DART AEROSPACE LTD	Work Order:	97415
Description: Crosstube Assembly, Mid Aft	Part Number:	D206-667-247TRN
Inspection Dwg: D206-667-247 Rev: A		Page 1 of 2

A	NEW ISSUE	CP	10.12.23
REV.	DESCRIPTION	BY	DATE
DESIGN	97	DART AEROSPACE LTD	
DRAWN	97	HAWKESBURY, ONTARIO, CANADA	
CHECKED		DRAWING NO.	REV. A
MFG. APPR.		D206-667-247	SHEET 1 OF 4
APPROVED		TITLE	SCALE
DE APPR.		CROSSTUBE ASSY (206L MID AFT)	NTS
DATE	10.12.23	COPYRIGHT © 2010 BY DART AEROSPACE LTD THIS DOCUMENT IS PRIVATE AND CONFIDENTIAL AND IS SUPPLIED ON THE EXPRESS CONDITION THAT IT IS NOT TO BE USED FOR ANY PURPOSE OR COPIED OR COMMUNICATED TO ANY OTHER PERSON WITHOUT WRITTEN PERMISSION FROM DART AEROSPACE LTD

DRAWING NO. D206-667-247	TITLE CROSSTUBE ASS'Y (206L MID AFT)	REV. A	DART AEROSPACE LTD ENGINEERING ORDER		D.E.O. NO. D206-667-247-A-1	SHEET NO. SHEET 1 OF 1	SCALE NTS
DRAWN <i>q</i>	CHECKED <i>ASS</i>	MFG. APPR. <i>AB</i>	APPROVED <i>AMP</i>	DE APPR. <i>#</i>			
DATE 11.07.15	DATE 11.07.20	DATE 11.07.21	DATE 11/07/21	DATE 11.7.21

REPLACE MAGNOBOND WITH PROSEAL.

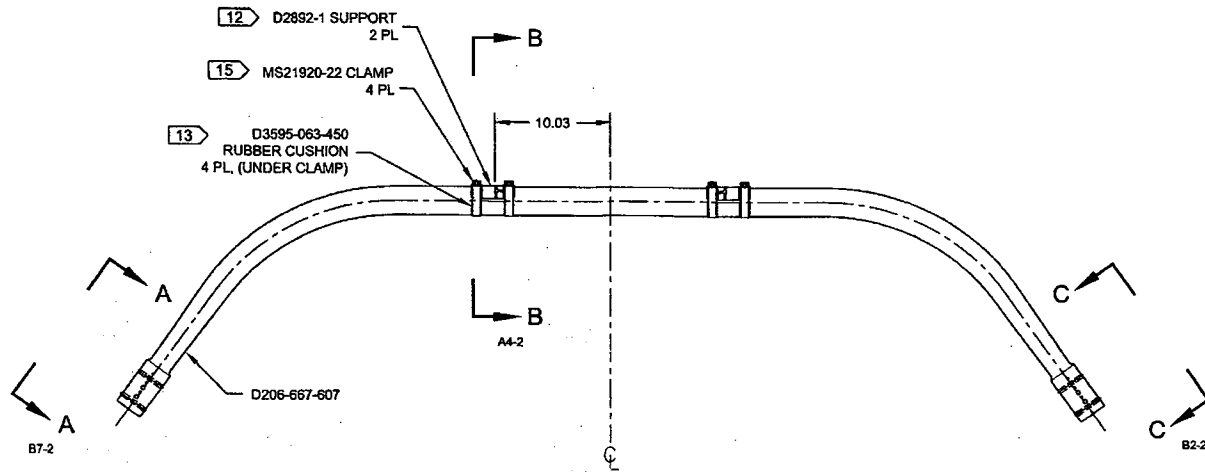
NOTE 12 & 15, SHEET 1 IS AMENDED AS FOLLOWS:

- 12) INSTALL D2892-1 SUPPORT USING 0.03" TO 0.06" THICK LAYER OF MAGNOBOND 6398 PER QSI 015. LET CURE FOR 12 HOURS AFTER INSTALLATION AND PRIOR TO PACKAGING.
- 15) TORQUE CLAMPS 80 TO 100 IN-LB. ENSURE AT LEAST 1.5 THREADS SHOWING IN SAFETY AND THAT NUT HAS NOT BOTTOMED-OUT AFTER TORQUING.

- 12) TO INSTALL D2892-1 SUPPORT: ABRASE MATING SURFACE OF SUPPORT AND CROSSTUBE WITH 180-GRIT SANDPAPER AND REMOVE RESIDUE WITH MEK (OR EQUIVALENT). APPLY A 0.04" TO 0.07" THICK LAYER OF PROSEAL 890 CLASS B-2 (OR AMS-S-8802 CLASS B-2) SEALANT TO MATING SURFACE OF SUPPORT.
- 15) TORQUE CLAMPS 80 TO 100 IN-LB. ENSURE AT LEAST 1.5 THREADS SHOWING IN SAFETY AND THAT NUT HAS NOT BOTTOMED-OUT AFTER TORQUING. **PRIOR TO PACKAGING, RE-CHECK TORQUE ON CLAMPS AFTER PROSEAL 890 SEALANT HAS CURED FOR 72 HOURS.**
